# CPED STAFF REPORT

CPC Agenda Item #3  
 July 14, 2014  
 BZZ-6602

**Property Location:** 55 28<sup>th</sup> Avenue North  
**Project Name:** Williams Building Parking Lot  
**Prepared By:** [Mei-Ling Anderson](#), City Planner, (612) 673-5342  
**Applicant:** Unison Comfort Technologies  
**Project Contact:** Jay Althof  
**Request:** To allow a surface parking area with 141 vehicle spaces and serving employees of the property at 60 28<sup>th</sup> Avenue North.

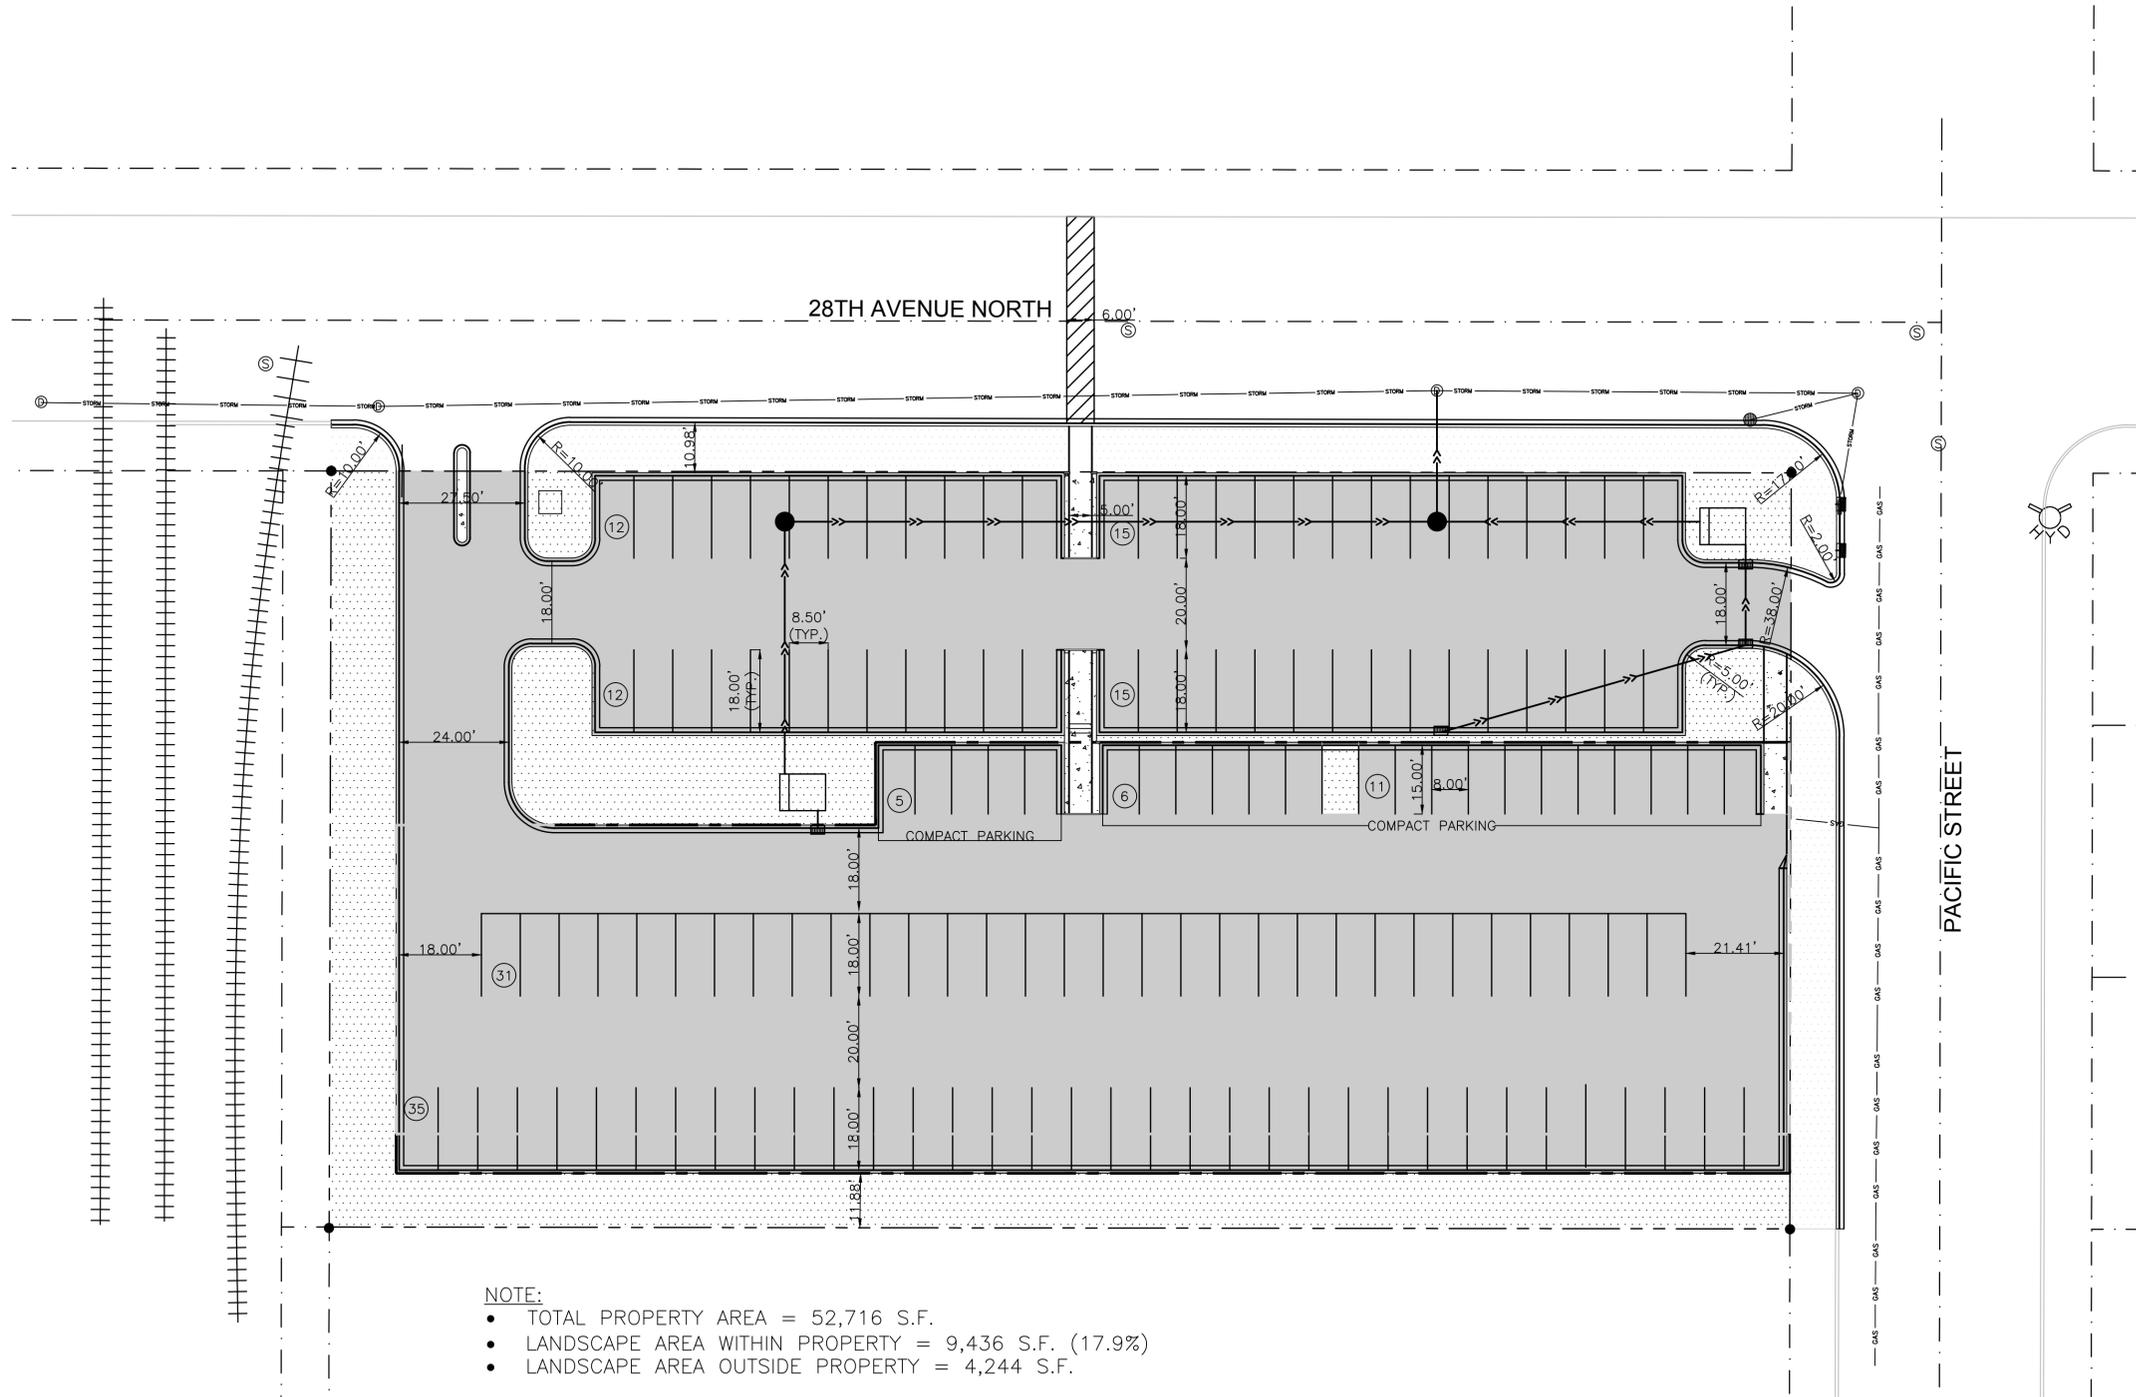
- The existing spot elevations on Sheet C1.0 are too small to read. Please correct this so the existing drainage patterns of the site are clearly demonstrated.

**SITE PLAN**  
UNISON  
55 28TH AVENUE N. MINNEAPOLIS, MN

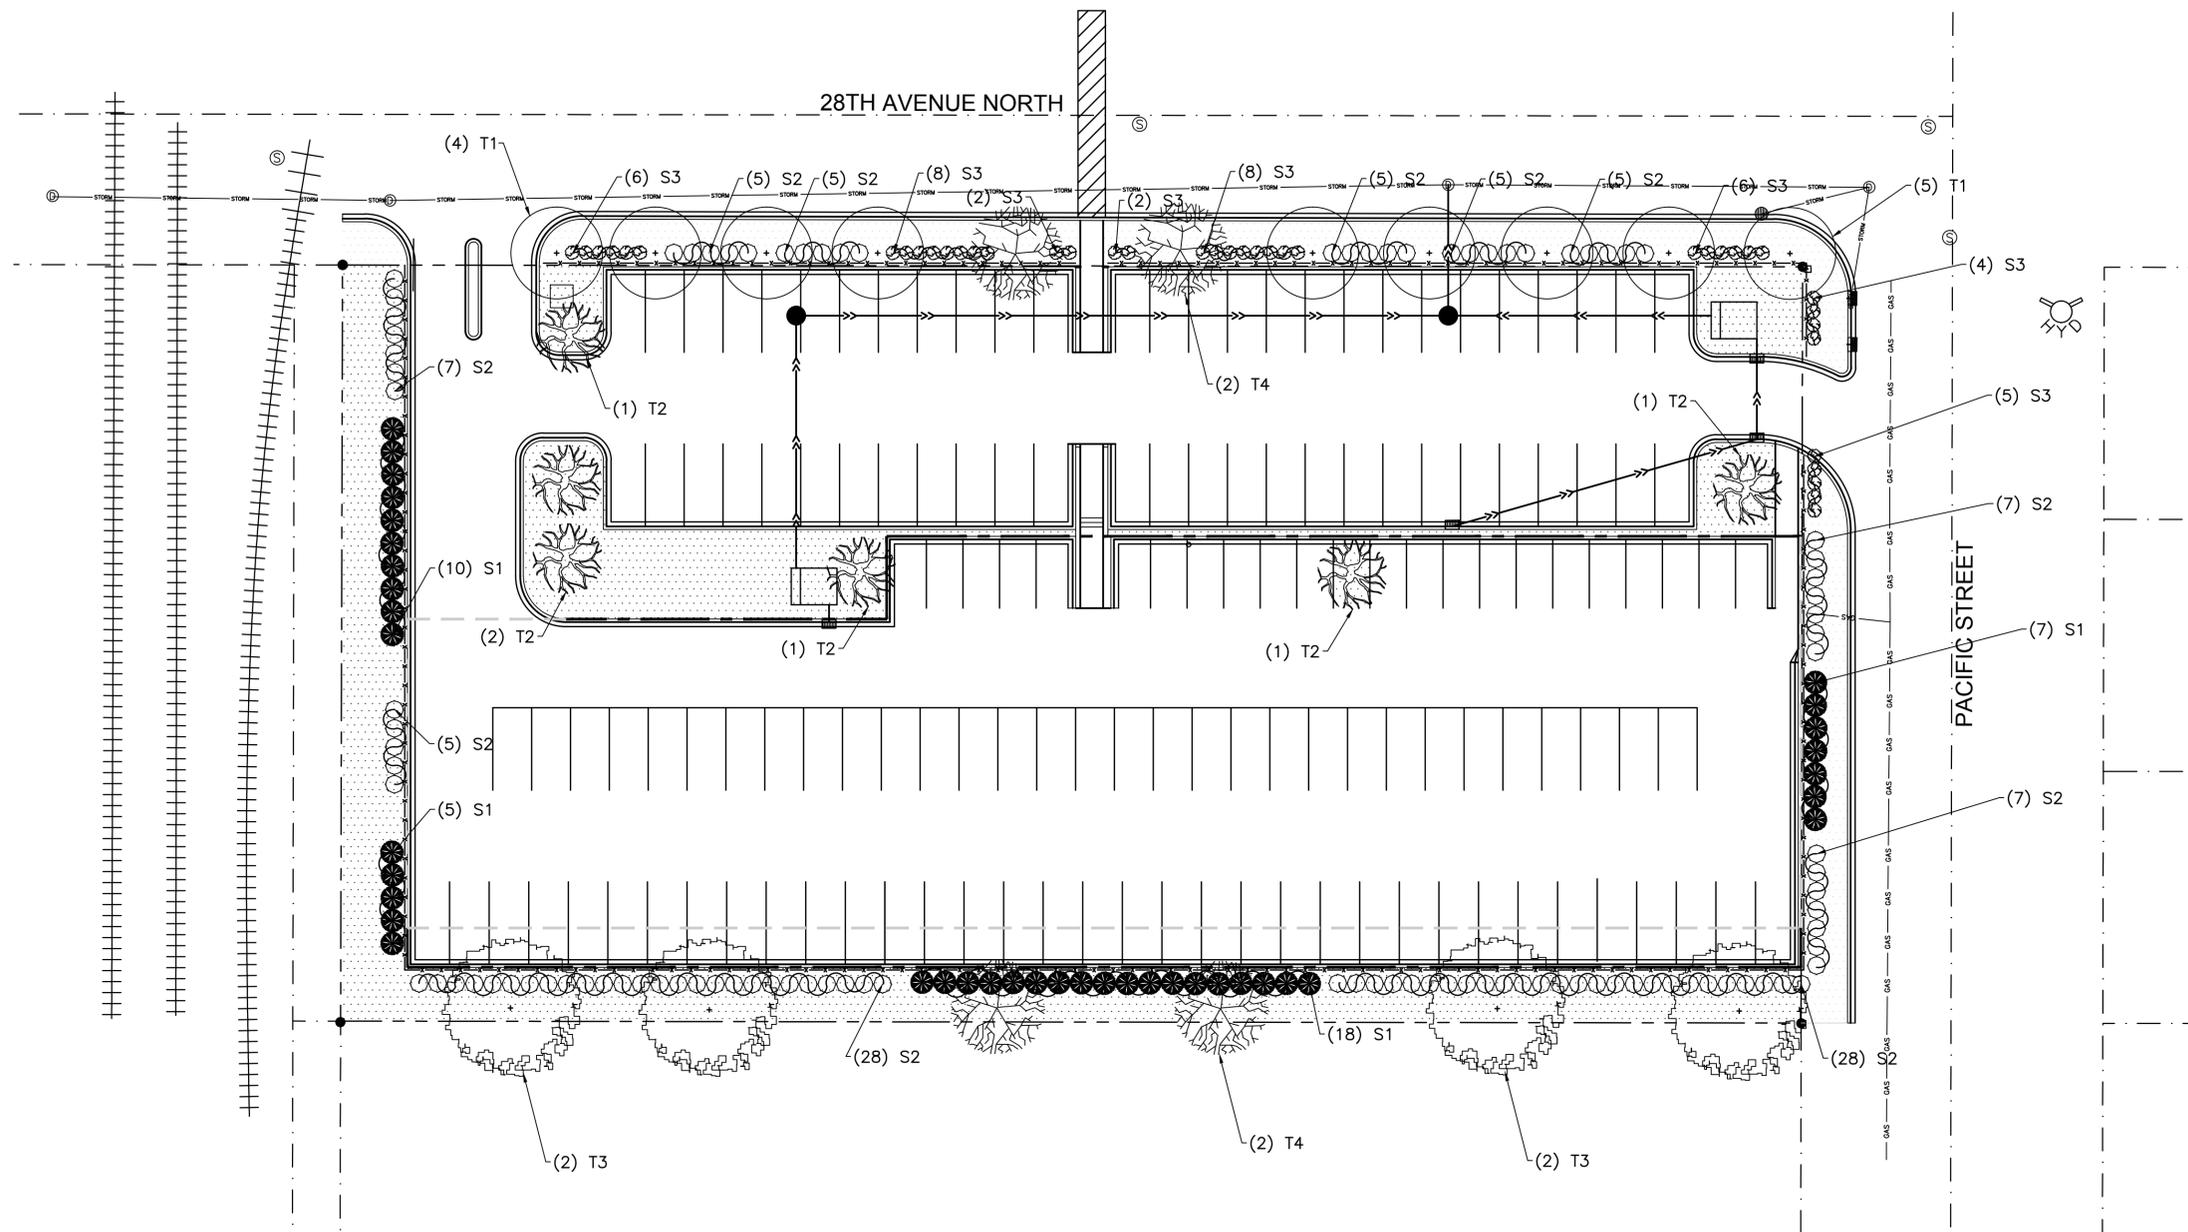
- Alternative compliance is being requested for many of the landscaping requirements in Chapter 530, Site Plan Review. In particular, the plans do not show a 9 foot landscaped yard provided on the property along public street frontage (28th Ave N and N. Pacific Street) and 17.9% of the site is landscaped where the minimum requirement is 20%. The parking lot does not appear to meet the requirement that a canopy tree is being provided for every 25 feet of parking lot frontage or the requirement that every space be located within 50 feet of an on-site deciduous tree. Staff recommends eliminating as much of the alternative compliance as possible.

- The applicant might consider angled parking to provide additional on-site landscaping. The center row could have overlapping dimensions to save a few feet and make up a few stalls that they would be losing to gain landscaping on north frontage.

- Please provide the following updates on future iterations of the plans:
  - Remove the wheel stops.
  - Demonstrate how the transformer will be screened per Chapter 535.

- Label the compact spaces as such.
  - Please provide more details on the material of the fence.
  - Indicate the materials of all landscaped areas. The intent of the ordinance is to provide a mix of landscaping materials in all non-impervious areas, not just mulch (530.180).

- The parking lot exit to Pacific Street is not compliant; all vehicle access points shall have a minimum of 20' of straight curb before the intersection, and all vehicle access points shall be perpendicular to the roadway. Current ordinance states that vehicle circulation shall be done on site and curb cuts reduced and consolidated as much as possible. Without further information, it is recommended to revise the parking lot plans to eliminate the exit to Pacific Street.

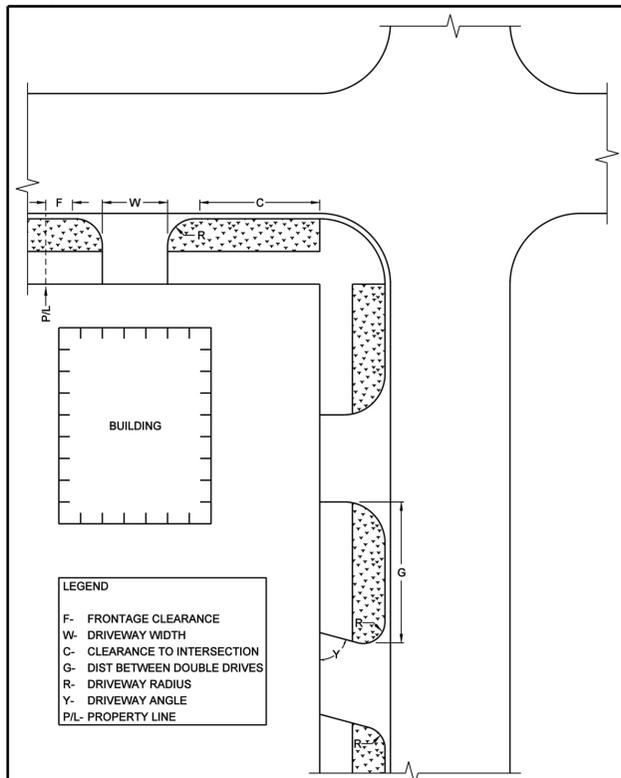
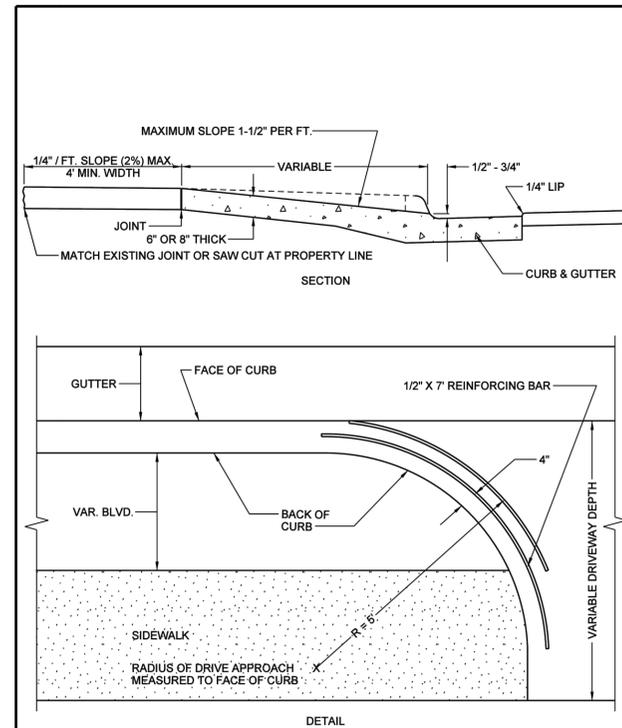
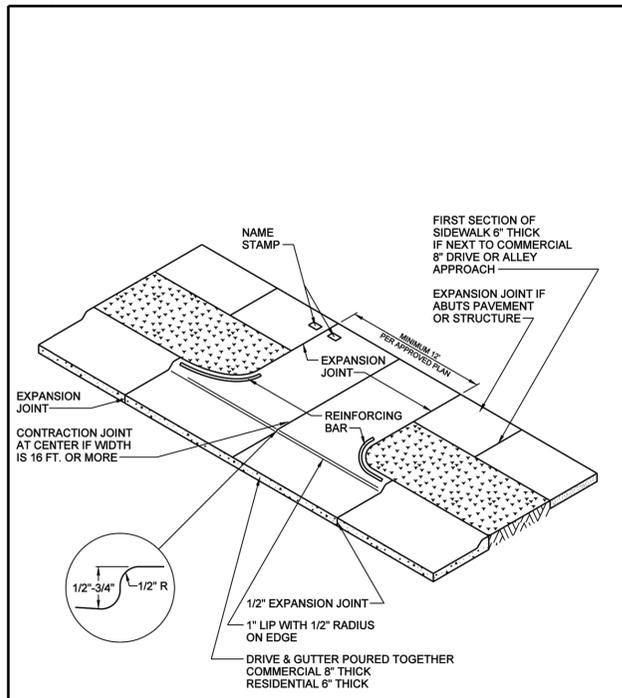
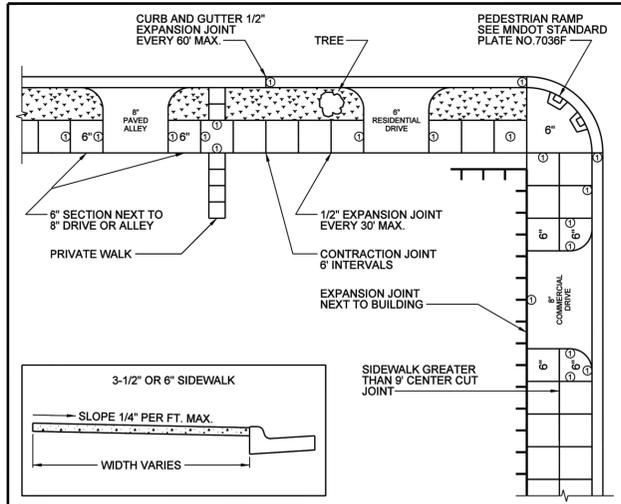
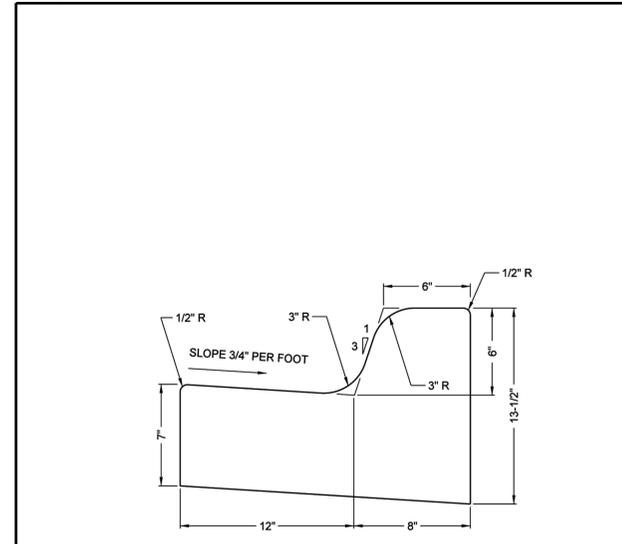
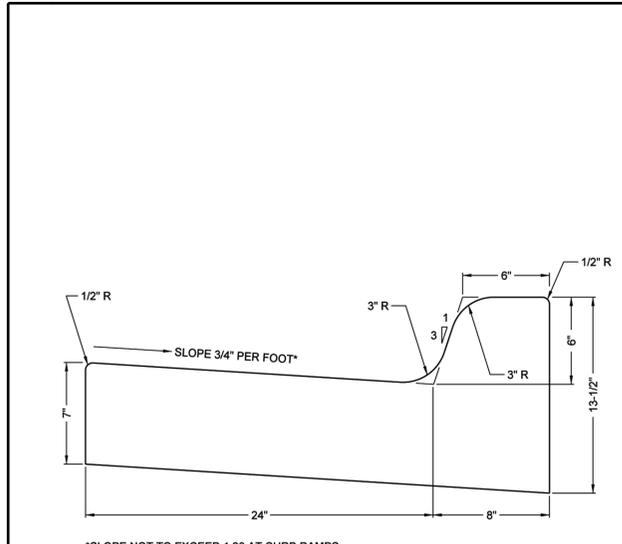
- All driveway aprons shall be designed and constructed to City standards. Please refer to the following:  
[http://www.minneapolismn.gov/publicworks/plates/public-works\\_road](http://www.minneapolismn.gov/publicworks/plates/public-works_road). Add the appropriate details from the ROAD-2000 Series: Driveways (ROAD-2000, ROAD-2001, ROAD-2002, ROAD-2003) to the plans. Proposed driveway aprons shall be shown graphically correct on all related site plan sheets. All driveway aprons shall be oriented at 90 degrees to the direction of travel of the adjoining roadway.

- All curb & gutter in the Public right-of-way shall be designed and constructed to City standards, curb & gutter to be City standard B624 Curb and Gutter. Please refer to the following:  
[http://www.minneapolismn.gov/publicworks/plates/public-works\\_road](http://www.minneapolismn.gov/publicworks/plates/public-works_road). Add the appropriate details from the ROAD-1000 Series - Curbs and Gutters (ROAD-1003, and ROAD-1010) to the plans. Top of Curb profiles shall be provided for any section of curb replacement in excess of 50 feet.
